From: Hamous-Miller - DNR, Lexi <lexi.hamous-miller@state.co.us>
Sent: Tuesday, May 14, 2024 2:17 PM
To: Rierner, Joseph
Cc: Spelts, Tracy L
Subject: [EXTERNAL] Re: CPW 1202.a(3) Waiver-Tulip Pad

Rule 1202.a.(3) (creeks/wetlands) Waiver Assessment

CHEMICAL STORAGE EXHIBIT

TULIP

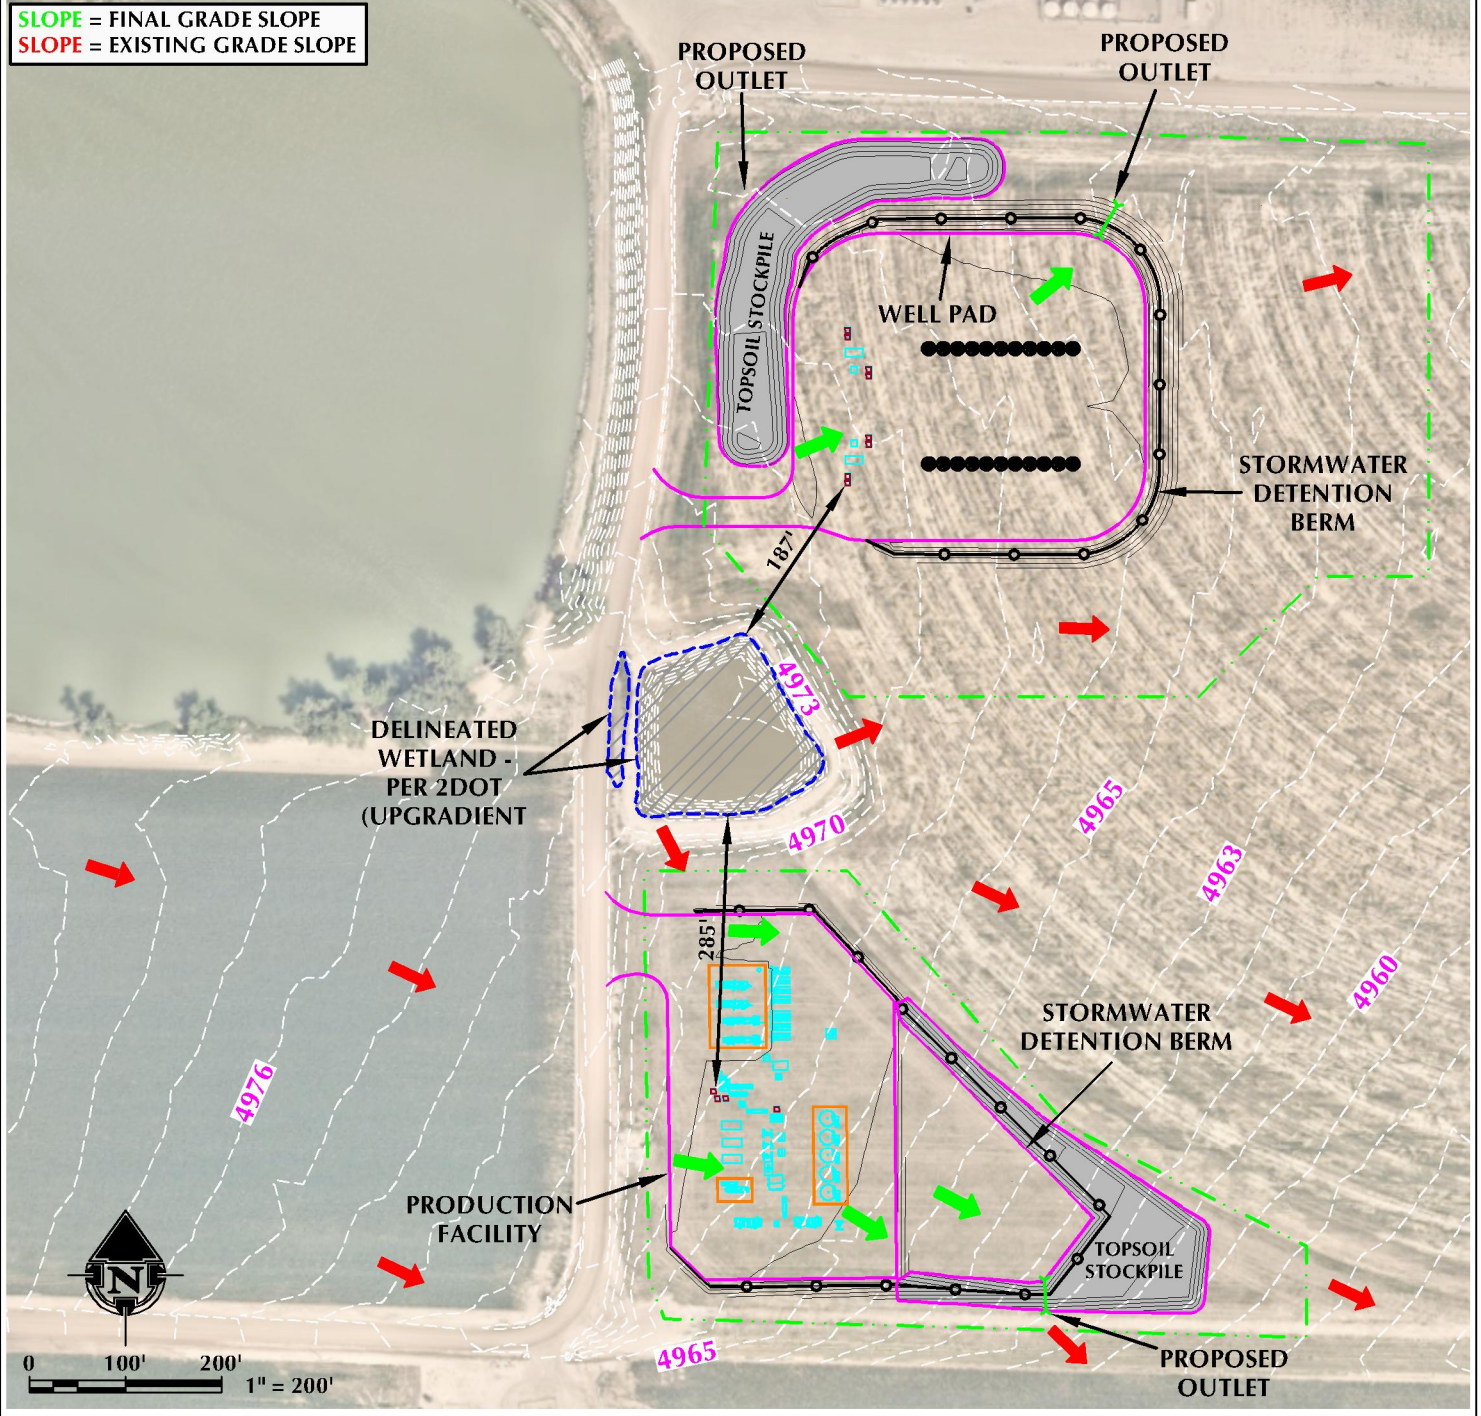
- This location does not occur within Aquatic High Priority Habitat.
- CPW asked KMOG for a formal wetland delineation by a Professional Wetland Scientist (PWS) or an equivalent knowledgeable wetland scientist and received the attached wetlands map, and observed there is one delineated wetland present within 500 ft of the planned Working Pad Surface (WPS).

- The closest edge of the wetland is located 187 feet upgradient of some of the chemical storage totes and 285 feet upgradient of the other chemical storage totes.

- The wetland is upgradient of this location, and with final grading, the flow would take any chemicals/sedimentation away (to the northeast and southeast) from the wetland.

- KMOG stated that *"the chemical totes that are used on KMOG locations in the DJ contain built in secondary containment and are made of steel. All other tanks on location will be within steel bermed secondary containment compliant with EPA rule 40CFR 112 Subpart A, B, C.."*

- Therefore, because of the above discussion, and because these wetlands within 500 feet of the WPS are not mapped as an Aquatic Native Species Conservation Water, CPW grants KMOG this signed waiver (per the requirement discussed in COGCC Rule 1202.a.(3)) requiring chemicals and new sites to be located more than 500 ft away from the wetlands and ditches.
